COLLIN COUNTY, TEXAS

ADDENDUM No. Two (2)

IFB NO. 2014-261

Construction, Collin County Walking Trail

Collin County Administration Utilities and Irrigation

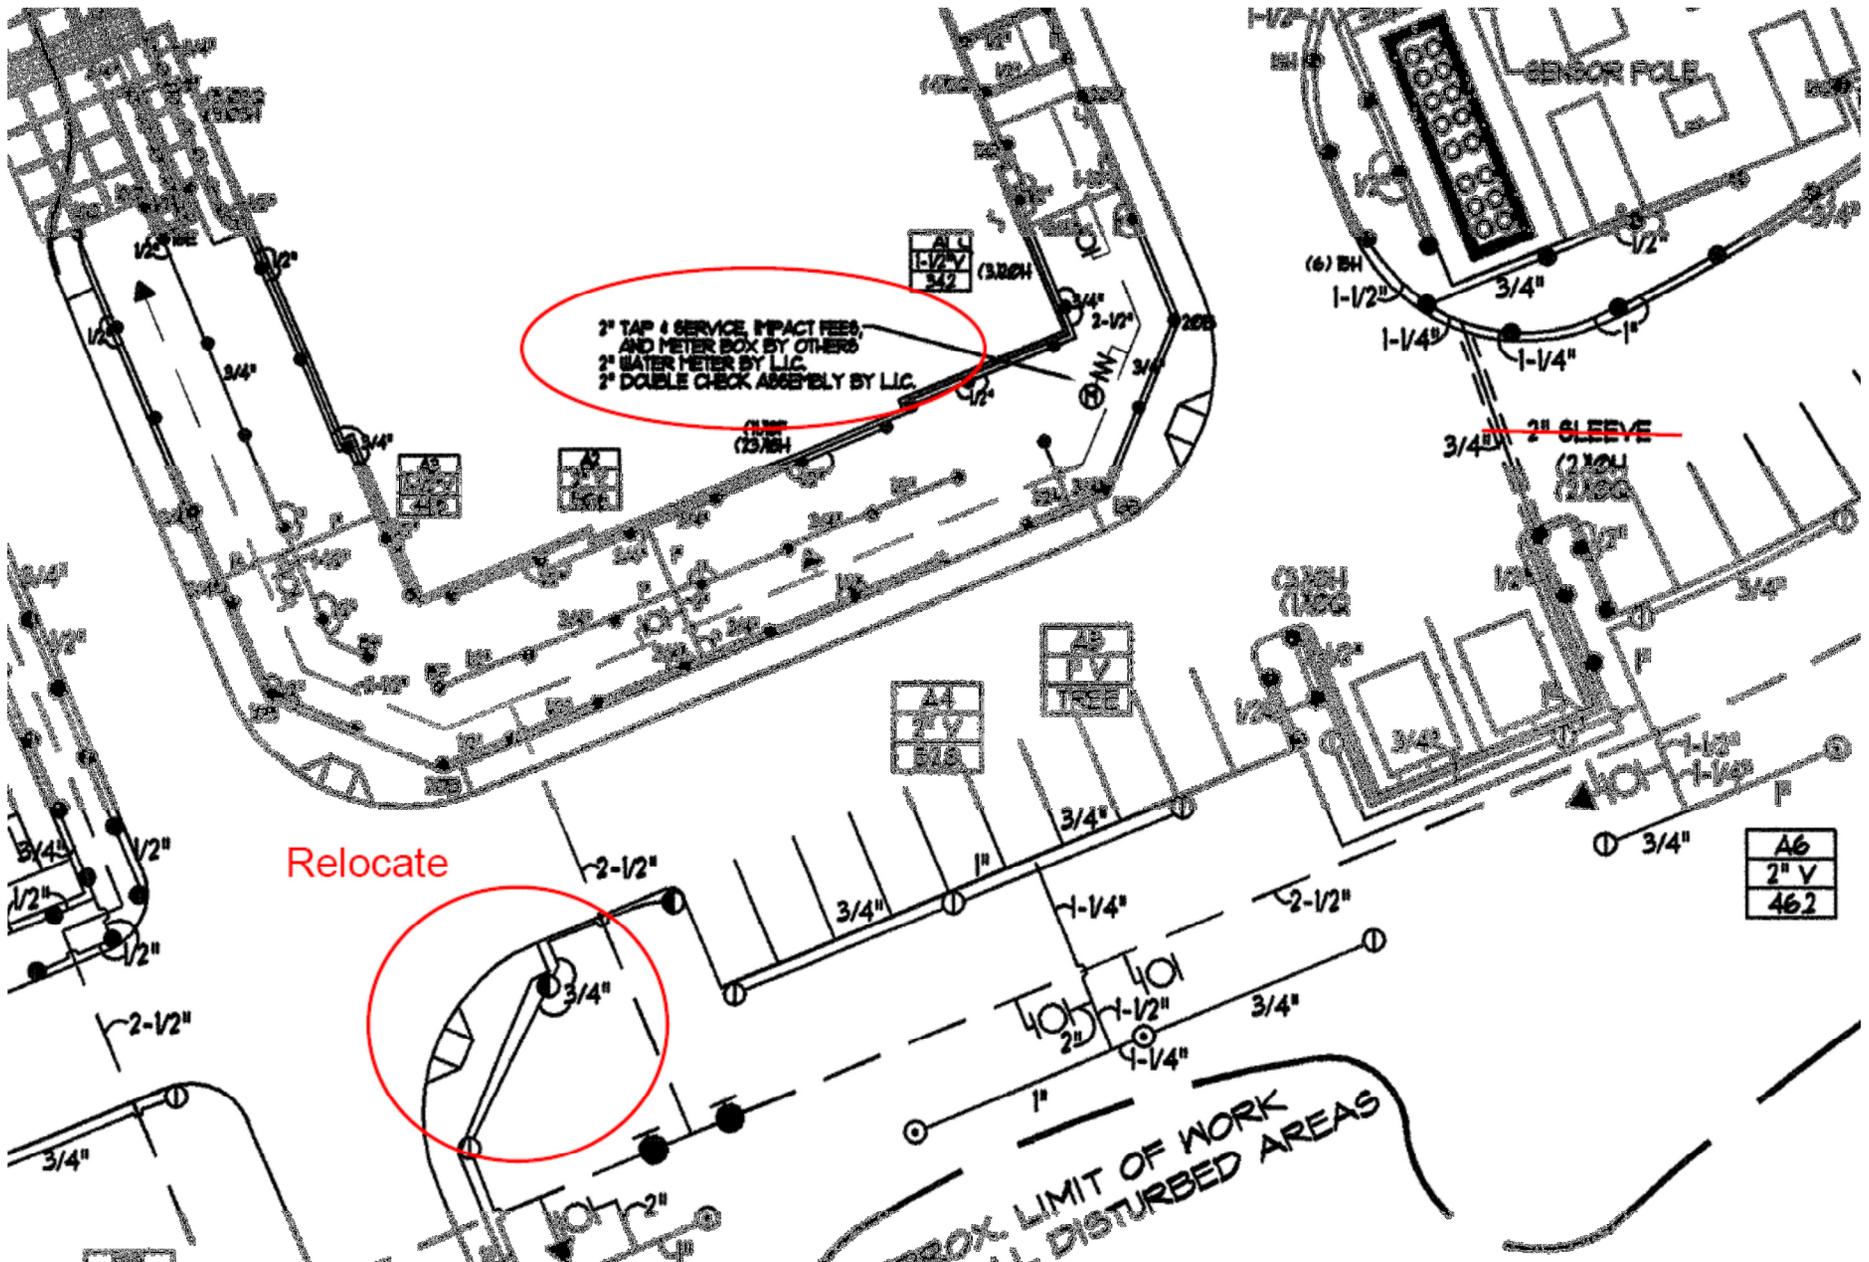
Item 48: Additional Information.

- A. Refer to attached PDF file "Admin Utilities and Irrigation" for additional information regarding required relocation of existing irrigation heads & piping at the end of the new trail near the Administration Building at STA 0+00.00 as shown on Sheet C2.

BRIDGE GUARDRAIL DTL

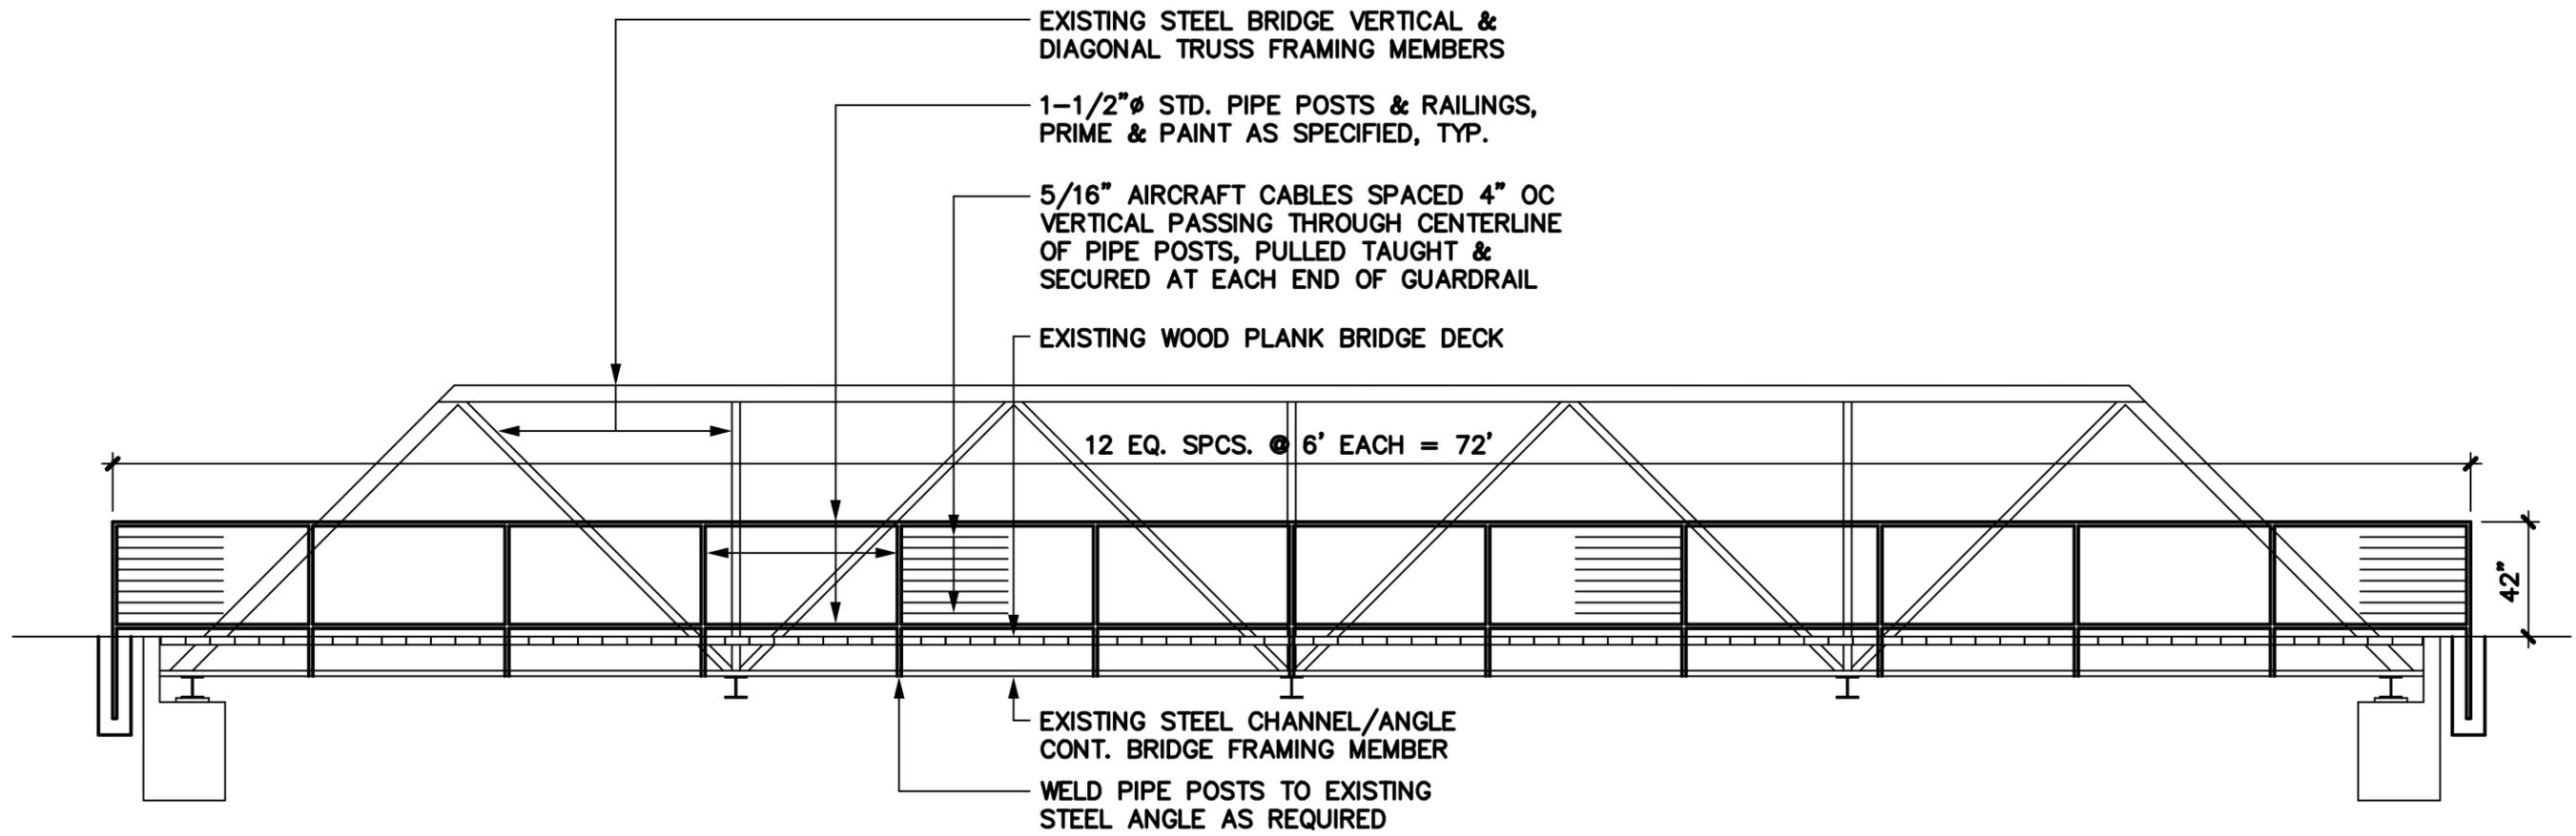
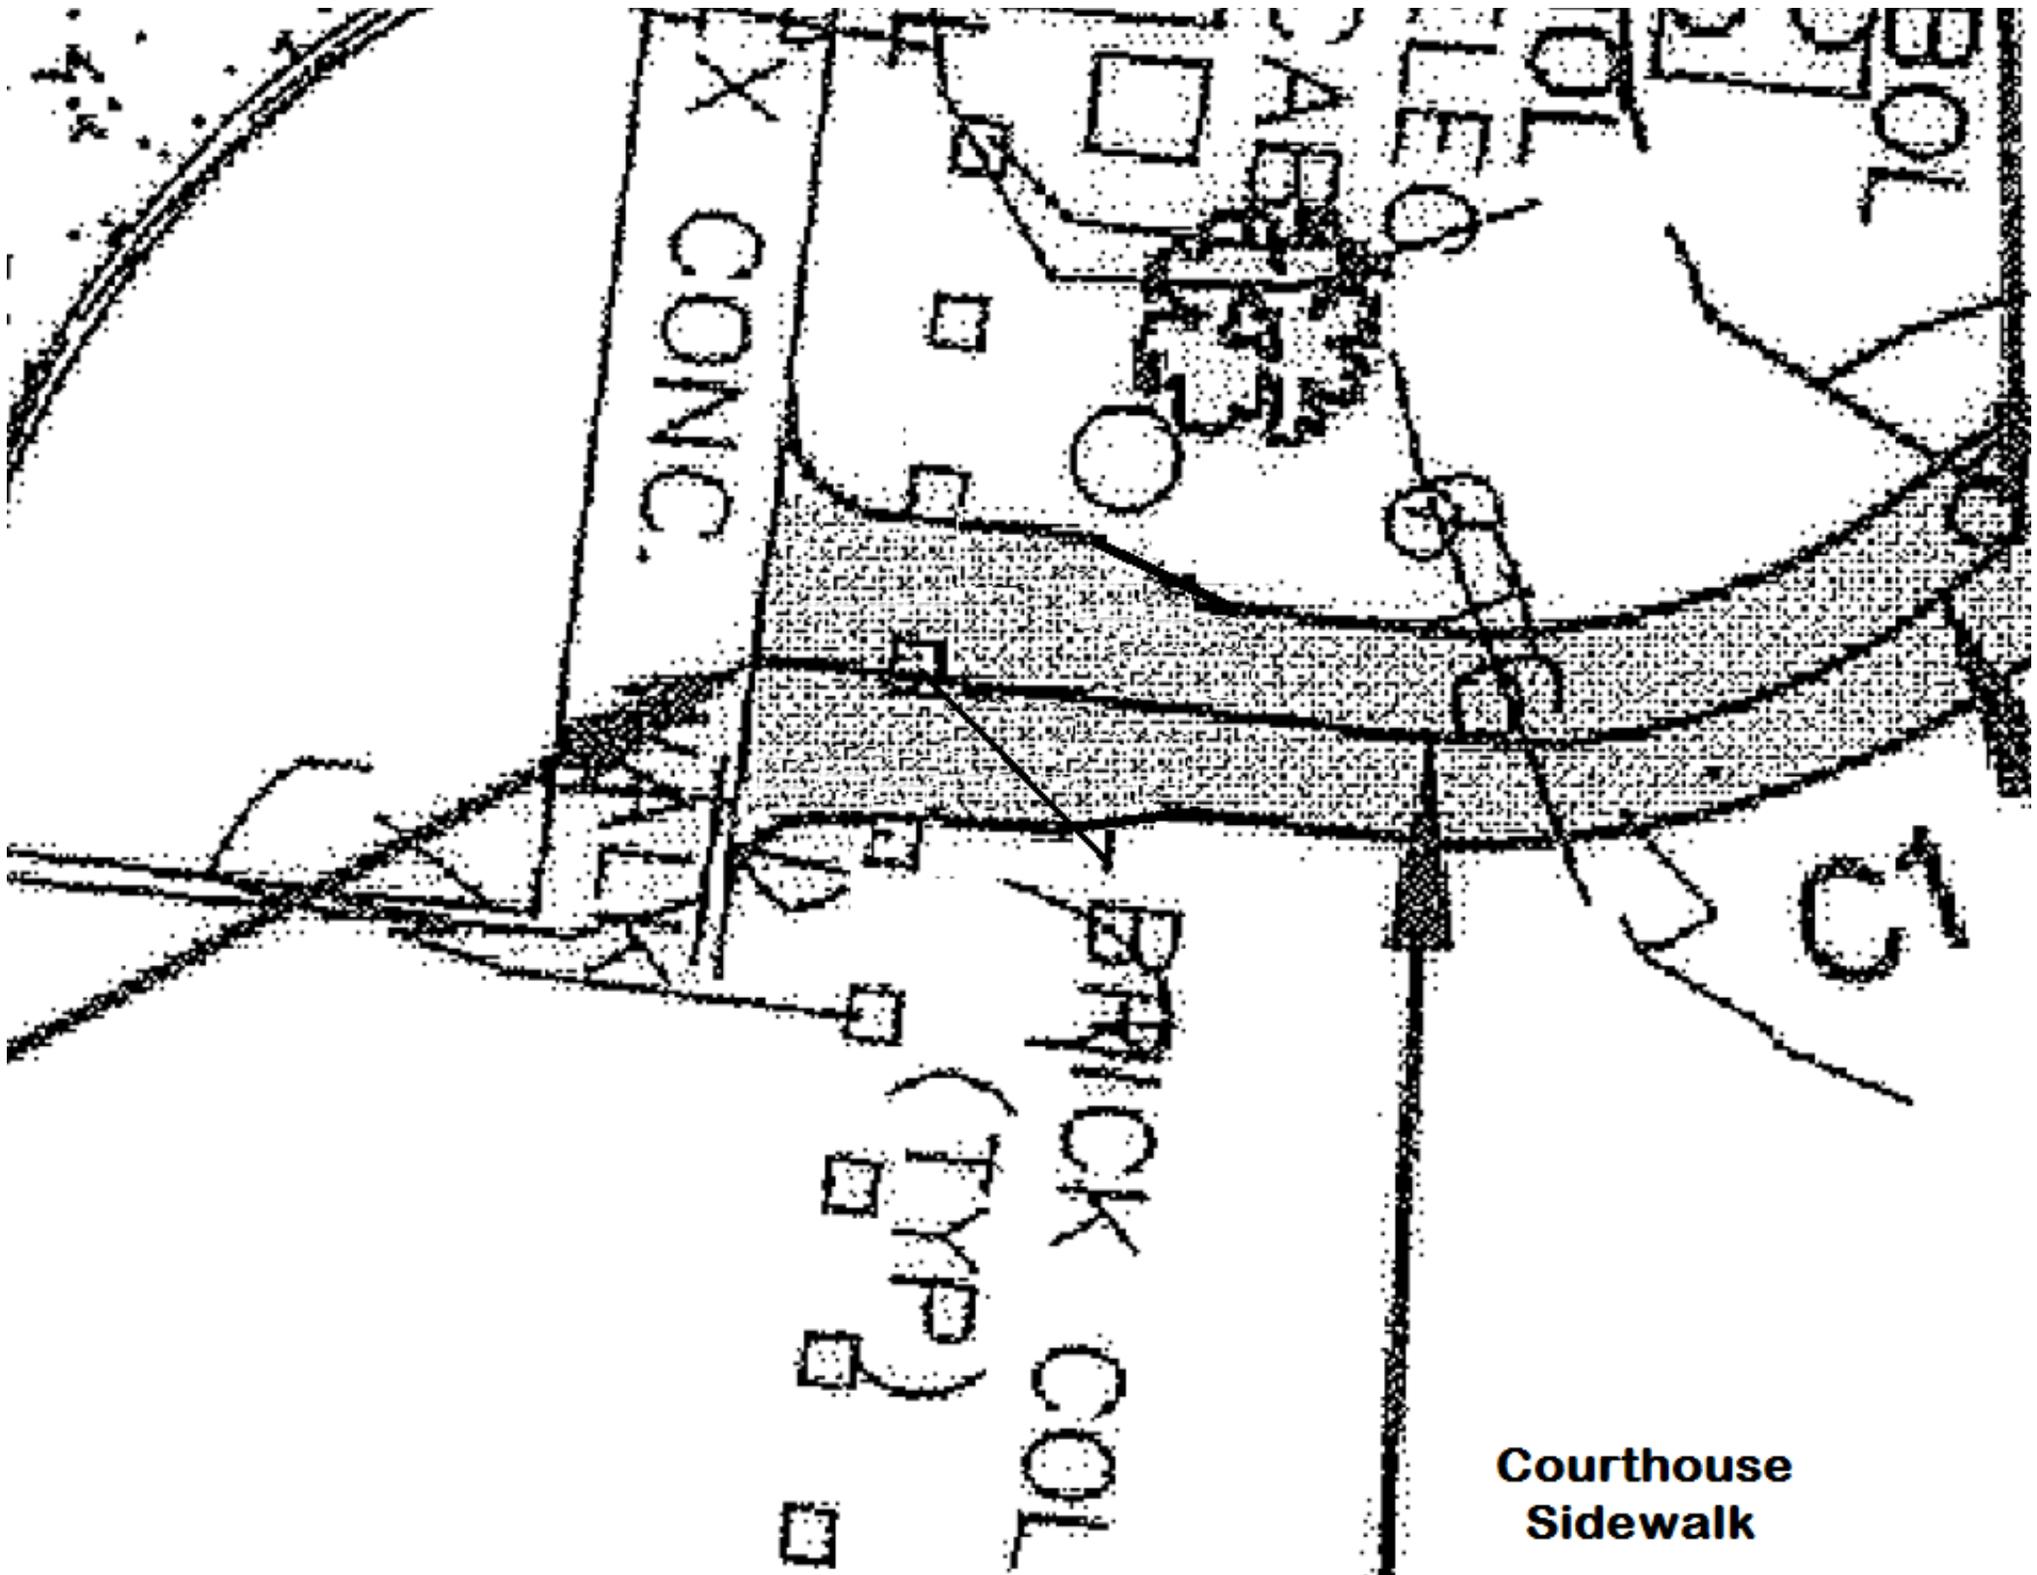
Item 46: Refer to Sheet C4 6' Walk East Side.

- A. At the existing bridge located between STA 4+56.18 & STA 5+37.99, add a steel pipe guardrail on each side of the bridge for the full length of the bridge (72 LF of guardrail each side of bridge) per elevation/detail on attached PDF files "Bridge Guardrail Detail" & "Bridge Guardrail Elevation". Guardrails shall extend approximately 1 FT beyond the concrete abutment on each end of the bridge with a terminal post anchored in a 12 IN DIA x 36 IN deep concrete footing and all intermediate posts being welded to the existing steel bridge structural frame as detailed.

**Courthouse
Sidewalk**

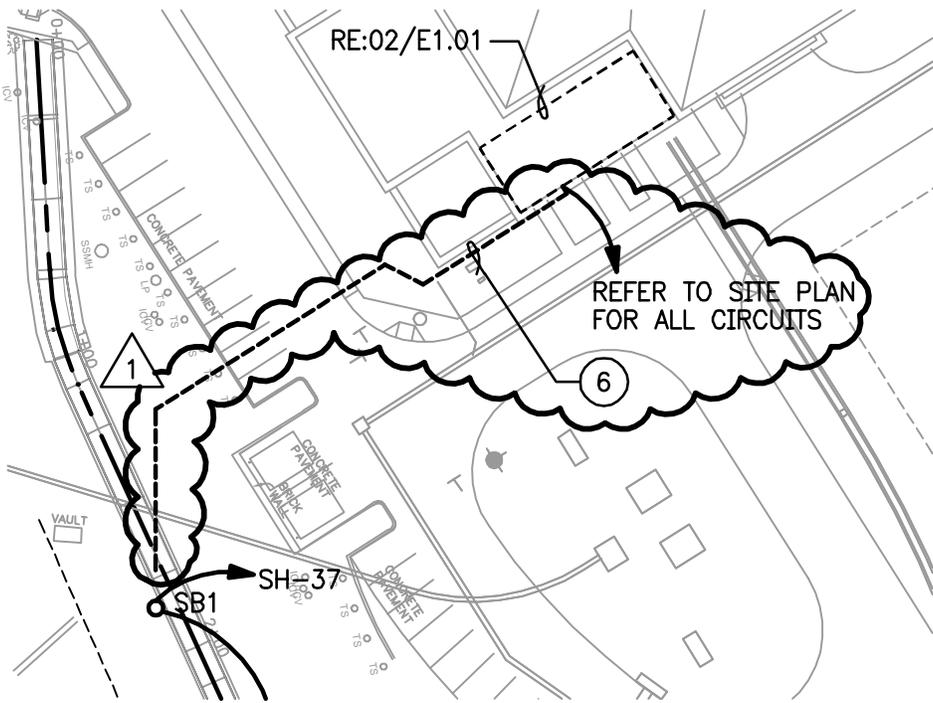
Item 41: Sheet E1.01; what is the preferred routing of the new electrical circuits from the site into the existing electrical room?

- A. Refer to attached PDF file "Circuit Routing to Elec Rm" for a revised site plan indicating the preferred routing of all new electrical circuits from the site into the existing Electrical Room.
- B. Refer to attached PDF file "Admin Utilities and Irrigation" for additional information regarding all of the approximate known locations of existing utilities on the south end of the Administration Building where the new electrical circuits will enter the existing electrical room.
- C. On Sheet E1.01 at Notes by Symbol, add a new Note #6 as shown on the attached PDF file "Circuit Routing to Elec Rm" which describes the preferred routing shown on the sketch.
